AIR — VARIABLE STATOR VANE ACTUATOR — INTRODUCTION OF VARIABLE STATOR VANE
ACTUATOR WITH IMPROVED FORCE CAPABILITY

Turbojet Engine Service Bulletin No. V2500-ENG-75-0122 Revision No. 4 dated July 2, 2019.

SERVICE BULLETIN

V2500-ENG-75-0122

FIGURE 1
Sheet 1 of 2

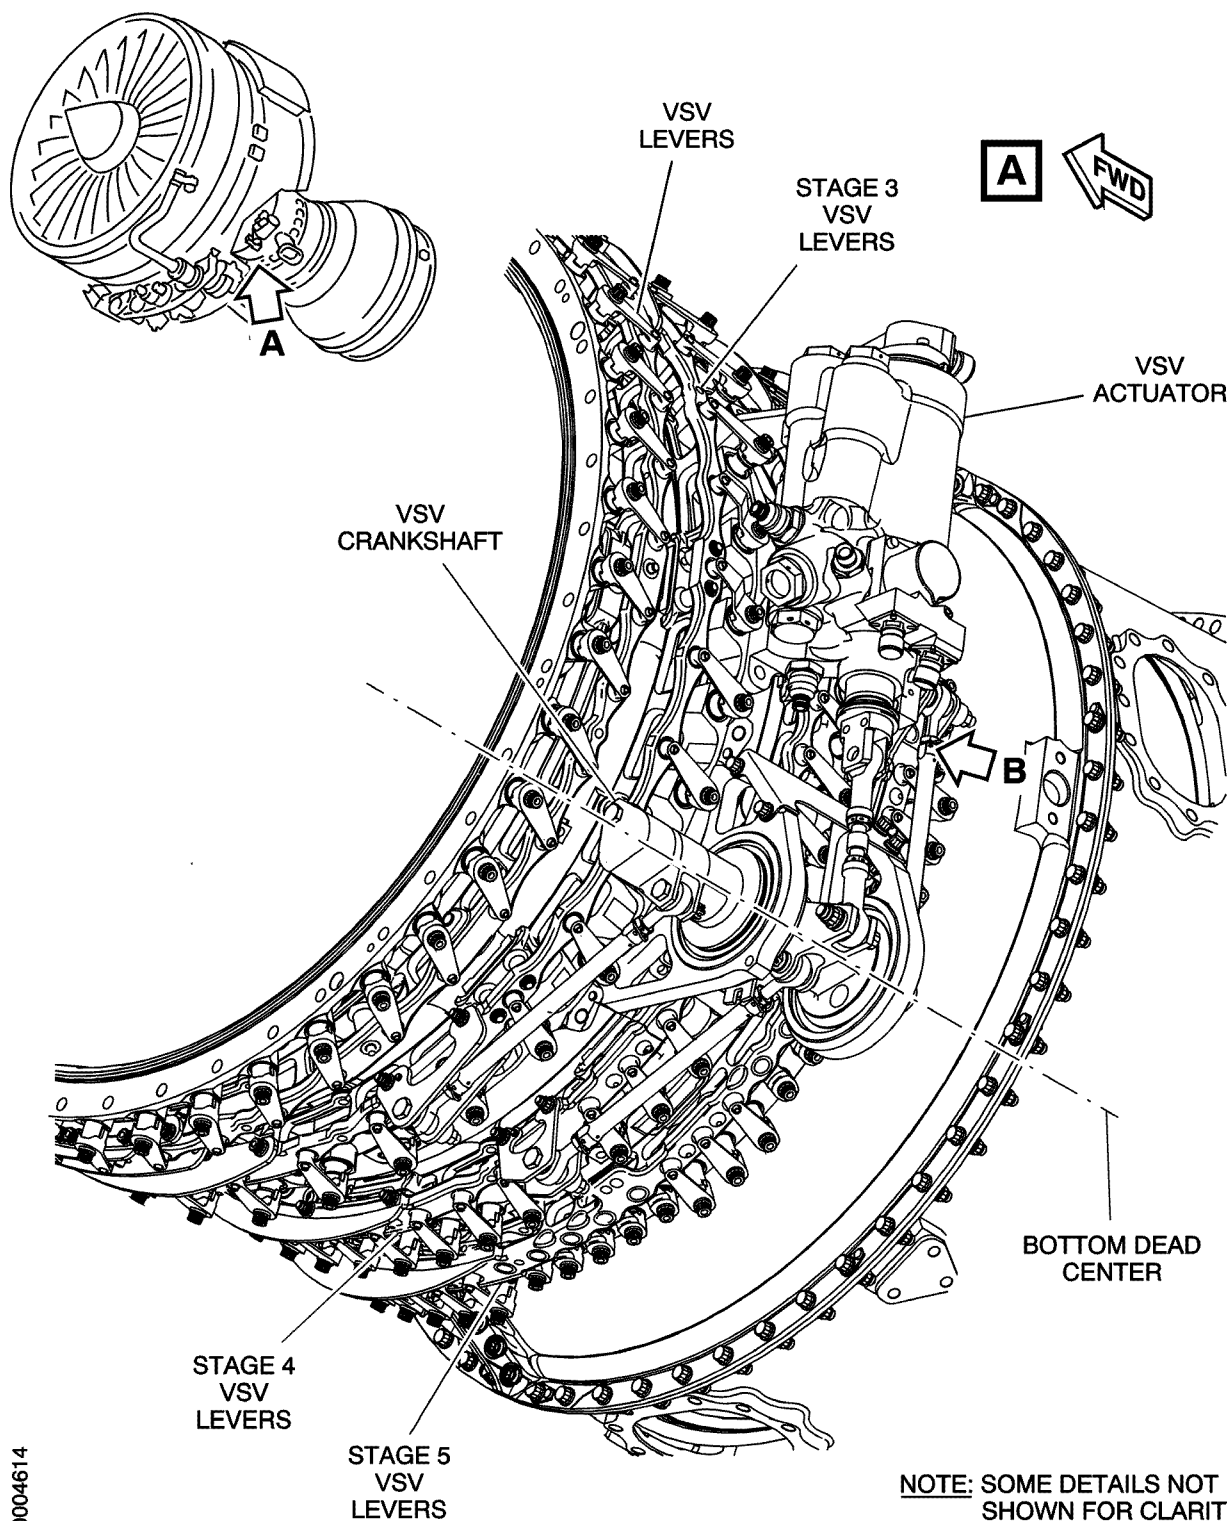
1. Replace the VSV Actuator, PN 2607MK3 or PN 1685MK8 with PN G4000VSVA01. See Reference 7, Aircraft Maintenance Manual and Figure 1.

NOTE: With the new VSV Actuator the rigging position has changed from forwards to rearwards.

- (1) Remove old VSV Actuator with TASK 75-32-41-000-010-A.

- (2) Install New VSV Actuator with TASK 75-32-41-400-010-A and Figure 1.

FIGURE 1
Sheet 2 of 2

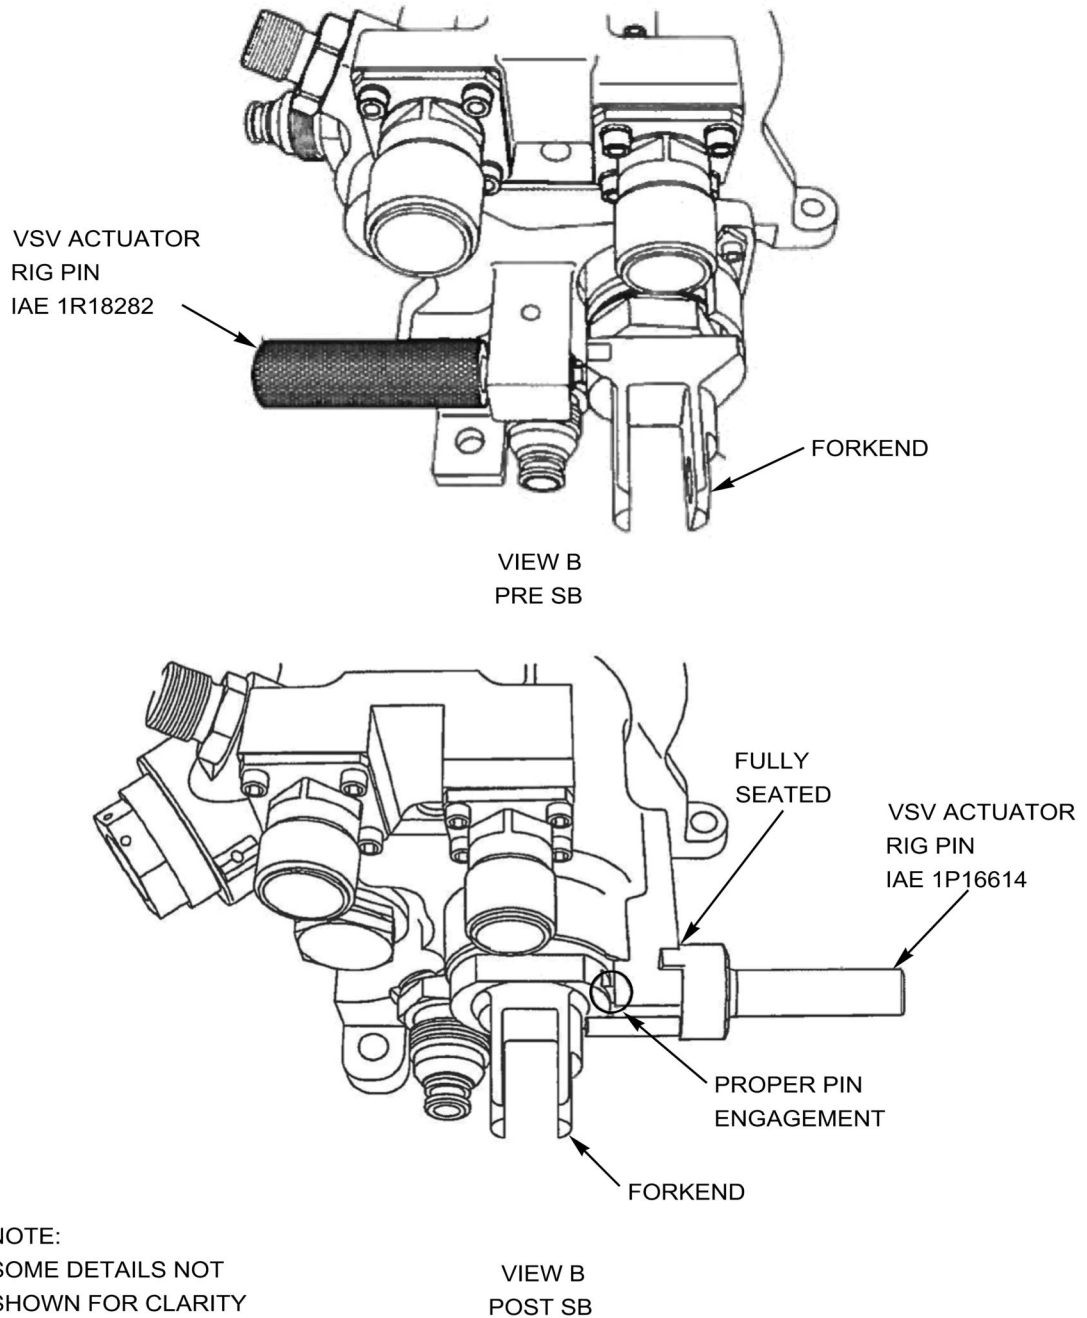
CAUTION: REFER TO FIGURE 1, SHEET 2. VERIFY VSV ACTUATOR RIG PIN PART NUMBER IAE1P16614 IS FULLY SEATED OVER ACTUATOR RIG PIN HOUSING AS SHOWN.

- (3) Visually inspect to insure proper rig pin engagement into Fork End slot as shown in Figure 1, Sheet 2 of 2.

CHART A

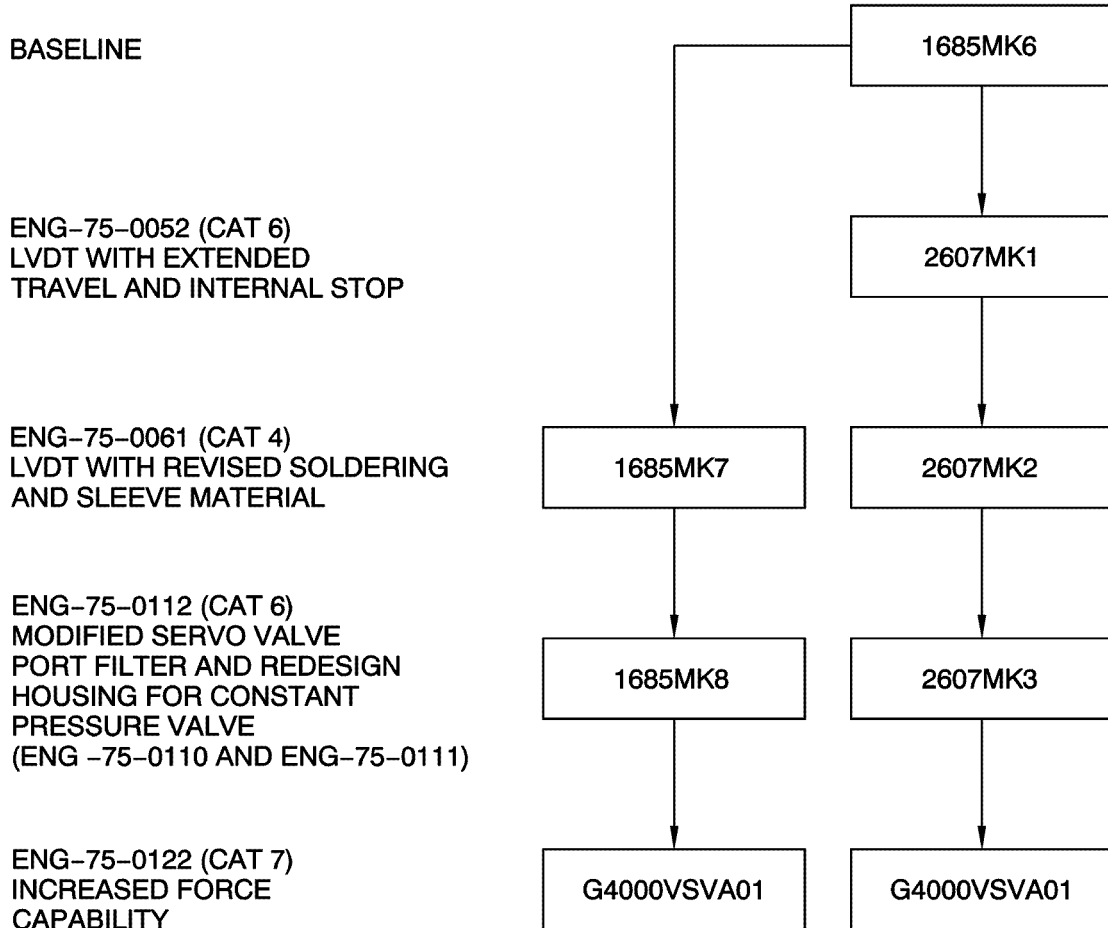
V2500-A5
PART NUMBER CHANGE
